Model Error Resolution Document <i>Complete only applicable items.</i>		QA: QA Page 1 of 27
INITIATION			
1. Originator: John Case	2. Date: 06/02/2008	3. ERD No. ANL-EBS-MD-000049 ERD 02

4. Document Identifier: ANL-EBS-MD-000049 REV 03 AD 02	5. Document Title: Multiscale Thermohydrologic Model		
6. Description of and Justification for Change (Identify applicable CRs and TBVs): Editorial corrections and clarifications to ANL-EBS-MD-000049 REV 03 AD 02 are made in response to CR-11935. In addition, deficiencies in data qualification as identified in CR-11936 are addressed. A justification for no impact to results of the subject report, and for other products that use output from this report as direct input, is also included. See attached pages for details.			
CONCURRENCE			
	Printed Name	Signature	Date

CR 11935 Evaluation

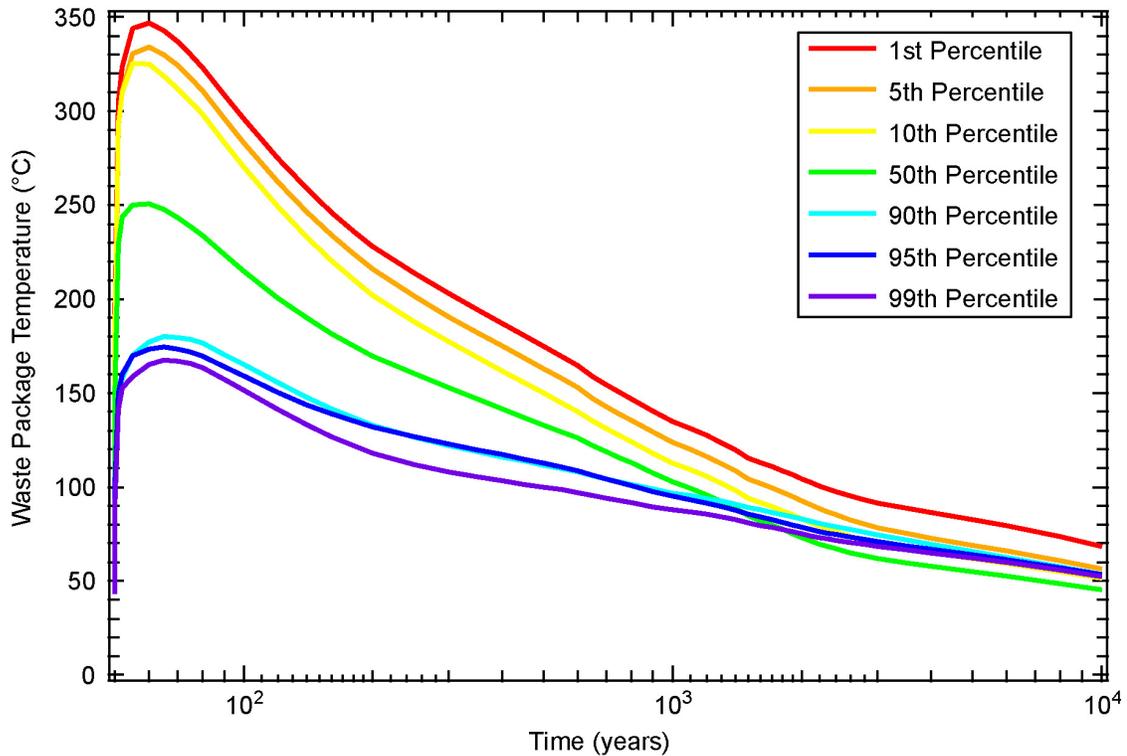
- II.35** (Issue 108 from surveillance; p. X-11[a]): *Section X.4[a]. Unsaturated...Invert. Line 2 of the paragraph mentions K_{us} . This is probably K_{ul} for which Eq. X-27 [a] defines a formula.*

AMR Change:

Appendix X[a], change all references to K_{ul} to read K_{us} .

The text for the presentation of the relative permeability relationship presented on p. X-11[a] is revised to read:

The relative permeability relationship is given by Fetter (1993 [DIRS 102009], p. 182, Equation 4.17) based upon the van Genuchten parameters and the conversion to hydraulic conductivity:
